City of El Paso – City Plan Commission Staff Report

Case No: SUSU12-00039 Mission Ridge Unit One
Application Type: Major Final
CPC Hearing Date: May 31, 2012
Staff Planner: Justin Bass, 915-541-4930, bassjd@elpasotexas.gov
Location: North of Eastlake Boulevard and East of Rojas Drive
Legal Description Acreage: 103.873 acres
Rep District: ETJ
Existing Use: Vacant
Existing Zoning: ETJ
Proposed Zoning: ETJ
Nearest School: Options Alternative School (0.94 mile)
Nearest Park: Loma Verde Park (2.08 miles)
Parkland Fees Required: N/A
Impact Fee Area: This property is not located within an Impact Fee Service Area and is not subject to impact fees.
Property Owner: Hunt Mission Ridge, LLC.
Applicant: Hunt Communities Holding GP, LLC.
Representative: Kimley-Horn & Associates, Inc.

ATTACHMENT 3

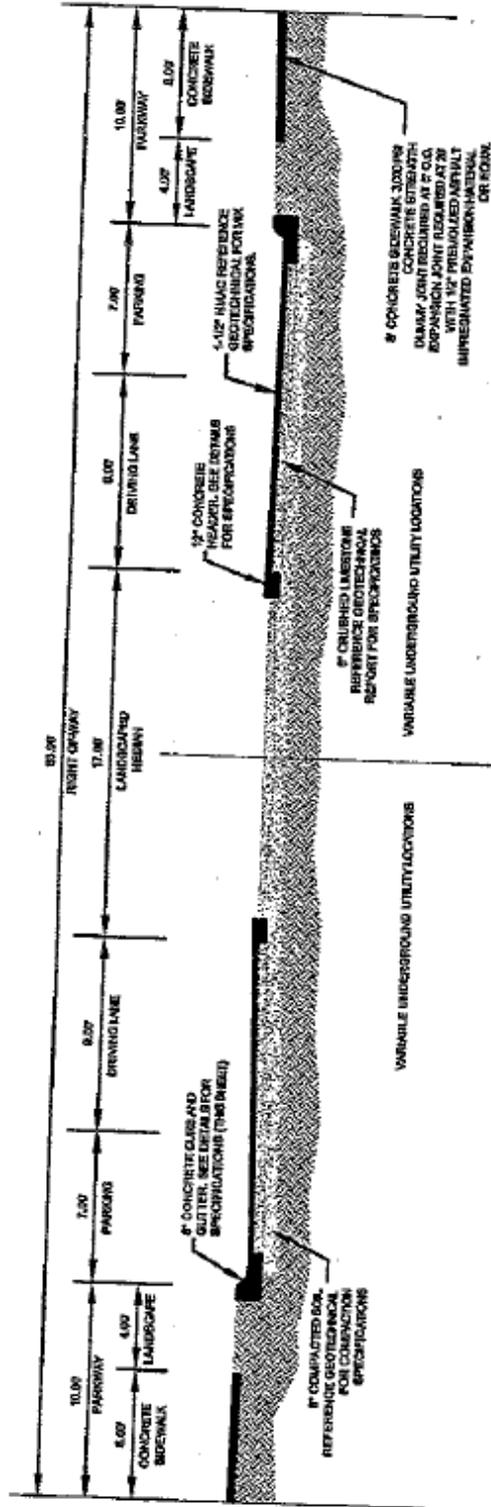
1. EPWU recommends dedicating Lots 12 & 60 of Block 11, Lot 25 of Block 4 and the drainage right-of-way between Lots 5 & 6 of Block 5 as ponding areas.
2. EPWU recommends dedicating drainage rights-of-way in lieu of *all* proposed drainage easements.

The El Paso County 911 District requests that **SILVER CROWN ROAD** be divided into three (3) separate segments with three separate names, due to potential emergency response hindrances with current street number addressing.

1. Inconsistency at address 12058 and 12160 area.
2. Create New street, address range accepted.
3. Create New street, however address range needs to be consistent with parallel neighbor, **Equestrian Road**, in the five digit range.

3. Applicant shall address the following comments prior to recordation:
 - Change date in approval block to 2012 from 2010.
 - Amend tax and restrictive covenants recording blocks by removing book and page lines.

- The CPC approval block shall be revised by replacing Development Services Director with City Engineer.
